- APPLICATION:
- A. Negative Declaration
 - B. Tentative Map to divide 16.3+ acres into one lot for 232 condominium air space units in the Multi-Family (Planned Unit Development) (R-2B(PUD)) zone
 - C. Special Permit to develop 232 condominium air space units on 16.3+ acres in the R-2B(PUD) zone

PROPOSAL: The applicant is requesting the necessary entitlements to develop 232 unit air space condominium units in the Metropolitan Center Phase II Planned Unit Development.

PROJECT EVALUATION: Staff has the following comments regarding this proposal:

SITE PLAN

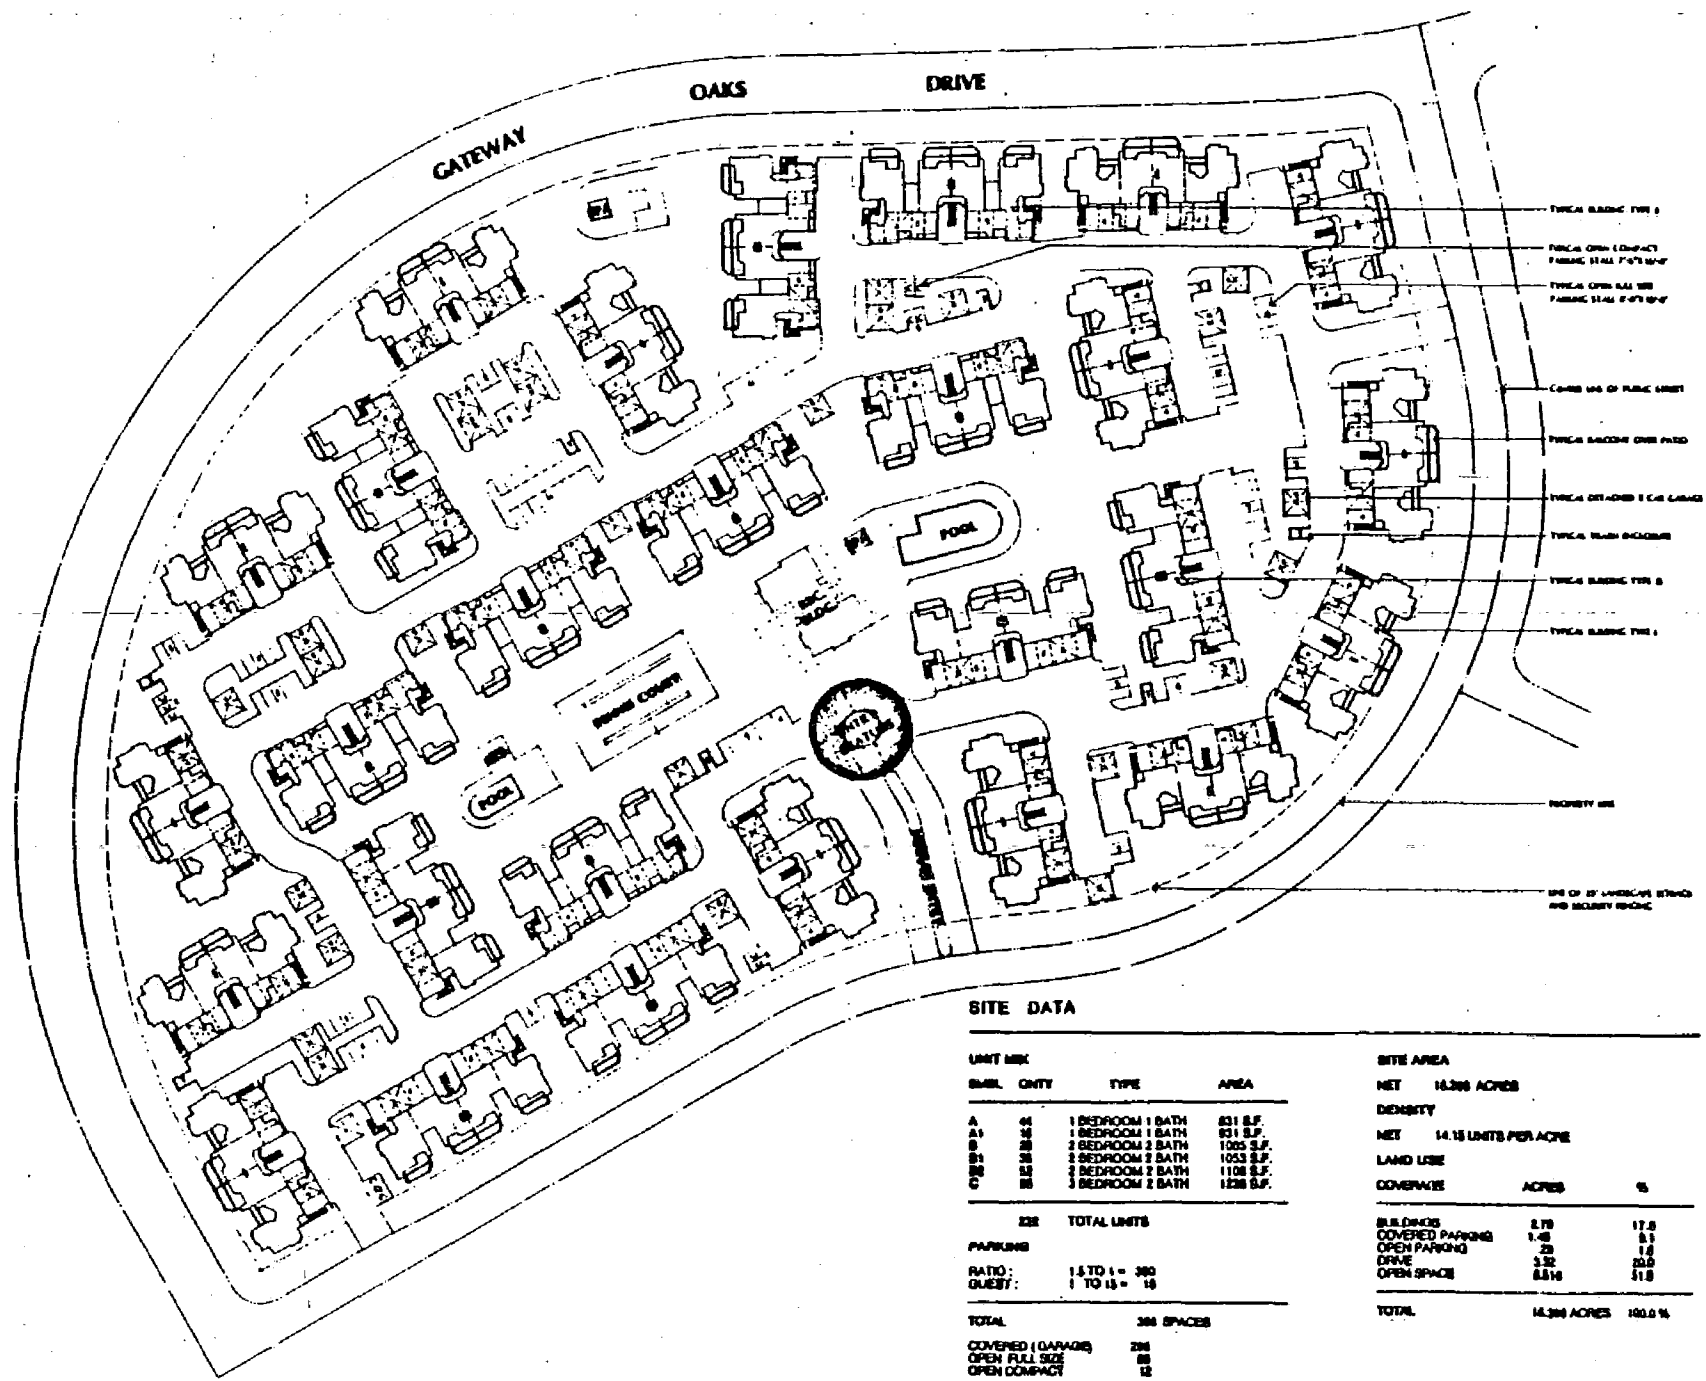
The submitted site plan indicates a 25' landscape setback along the entire perimeter of the site. One main entry with a water feature and one secondary entry is proposed on the subject site. The applicant has indicated to staff that a six foot decorative wall will be constructed along the perimeter of the site. The wall will, however, be broken up in some areas to not enclose the entire

site. Staff recommends that the design of the proposed decorative wall (photo or drawing) be submitted to staff for review and approval prior to issuance of building permits.

All trash enclosures indicated on the site plan shall comply with the City's Trash Enclosure Ordinance. Mechanical equipment (including public utility boxes) shall be attractively screened.

A minimum of one parking space in an enclosed garage is required for each unit. The Zoning Ordinance requires 1.5 parking spaces per each unit and one guest space per every 15 units. A total of 363 spaces are required for the subject site. The submitted site plan indicates 396 parking spaces which meets the parking requirement. Two hundred and ninety-six (296) spaces are covered garages, 88 spaces are open full size and 12 are open compact parking spaces. Handicap spaces shall be provided on the site and shall meet the building code requirement.

The City's Traffic Engineer had no objects to the proposed vehicle circulation within the project site. However, no vehicles shall enter or exit off of Gateway Oaks Drive.

1. A photo or drawing of the proposed wall along the perimeter of the subject site shall be submitted to staff for review and approval prior to issuance of building permits.
2. All trash enclosures shall comply with the City's Trash Enclosure Ordinance.
3. Mechanical equipment (including public utility boxes) shall be attractively screened.
4. The building shall contain at least three body colors to lessen potential monotony.

7. No vehicles shall enter or exit off of Gateway Oaks Drive.
8. All signage shall be subject to a Planning Director's Special Permit.
9. All landscaped entry ways etc. shall be maintained by an assessment district or a homeowners' association.

SIDE ELEVATION - BUILDING TYPE I

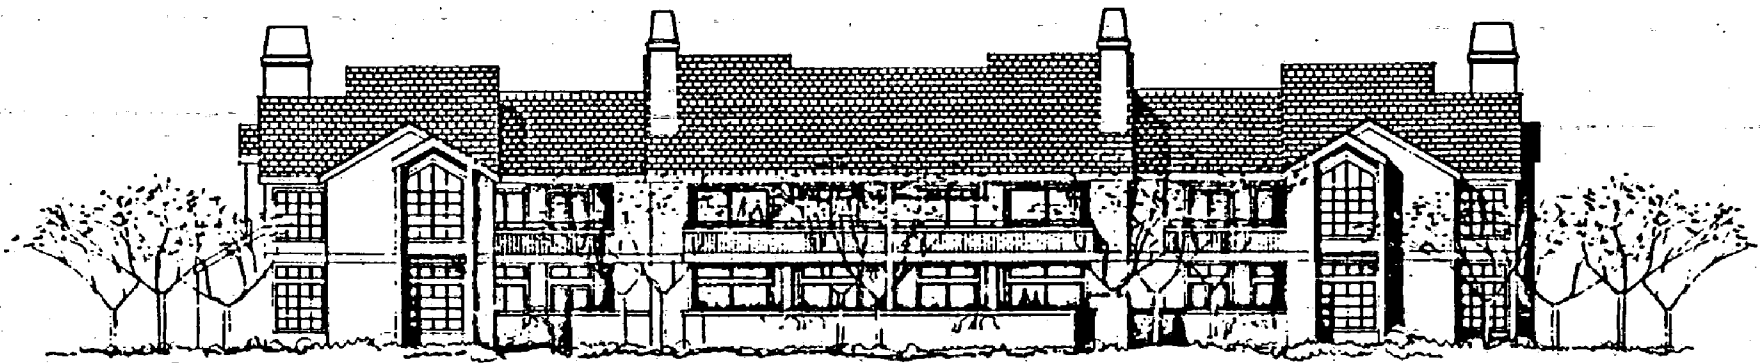
The Design Review Coordinator and Planning staff had some concern about the visual effect of the highest roof pitch in juxtaposition to the lower adjacent roof plane. This is particularly evident when viewing the residential site from the side elevation. Staff recommends that the applicant submit a roof plan of all building types prior to issuance of building permits. Staff was also concerned about the finish detailing of the stairways. Precast single stringer industrial type stairs are not allowed in residential developments.

5. A roof plan of all building types shall be submitted to the Planning Director prior to issuance of building permits.
6. Handicap spaces shall be provided on the site and shall meet the building code requirements.

REC. BUILDING ELEVATION FROM STREET

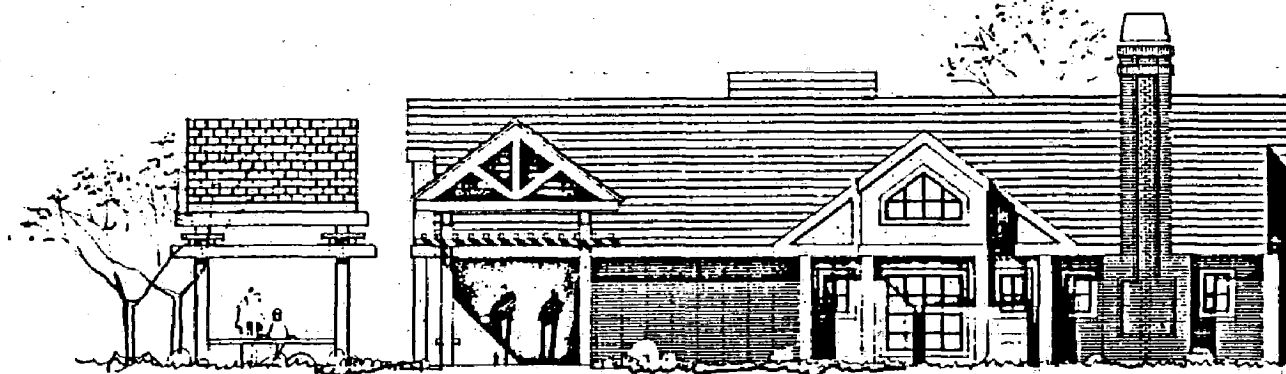
Floor plans and elevations for the condominiums and recreation building were submitted. The architectural style utilizes a variety of design elements and volumetric movement. The submitted plan indicates 80 one bedroom and one bath units (831 sq. ft. and 931 sq. ft.), 116 two bedroom and two bath (1,085 sq. ft., 1,053 sq. ft., 1,108 sq. ft.) and 56 three bedroom and two bath (1,238 sq. ft.) units. The proposed recreation building is 3,748 sq. ft. and its major services consist of an exercise room, reception room, party room, and TV room. The height of the condominium buildings is 36' (two story). The exterior building material consist of stucco and the roof material is made of concrete tile. Exterior building colors are brown tinted grey stucco with grey trim and a transparent stained grey siding. The elevation plans indicate white aluminum frame windows. Staff recommends that the applicant vary the main body color. The buildings shall contain at least three body colors that are subtle but noticeable to lessen potential monotony. In addition, a highlight trim color might be considered for the second floor balcony metal railing, attic vents, trim at metal chimney cap etc.

CONCEPTUAL LANDSCAPE PLAN

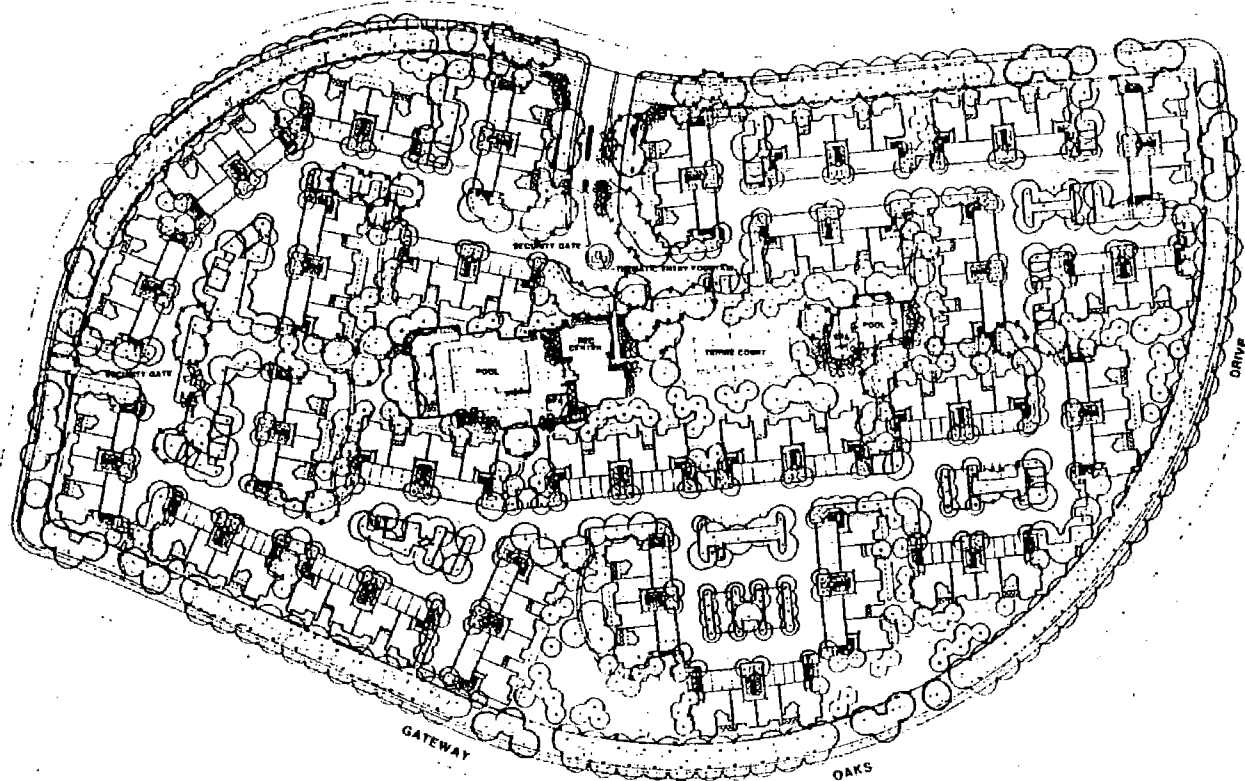
The applicant submitted a landscape and irrigation plan. A 25' landscape setback with 3-1/2' undulating berms are indicated on the site plan. The 25' of landscape berming proposed along all street frontages will serve to lessen the visibility of the guest parking areas and the condominiums as well. The landscaping will also discourage any parking on the street and along private on-site drives.

One security entry gate allowing pedestrians and vehicles (guest/residents) is identified on the plan. A thematic entry fountain is shown at the entrance. An additional security gate allowing residents with vehicles only is indicated on the site plan. Lastly, there are two pedestrian access gates on Gateway Oaks (see Exhibit H).

All entry areas are landscaped with evergreen and deciduous trees. The site plan also identifies 30' diameter Metro Center theme trees, 35' diameter accent shade trees and a range of 20'-25' diameter evergreen and deciduous trees. The applicant will be required to meet the 50% shading requirement for all surface parking areas. Staff feels that sufficient landscaping throughout the unit and recreation areas is provided.
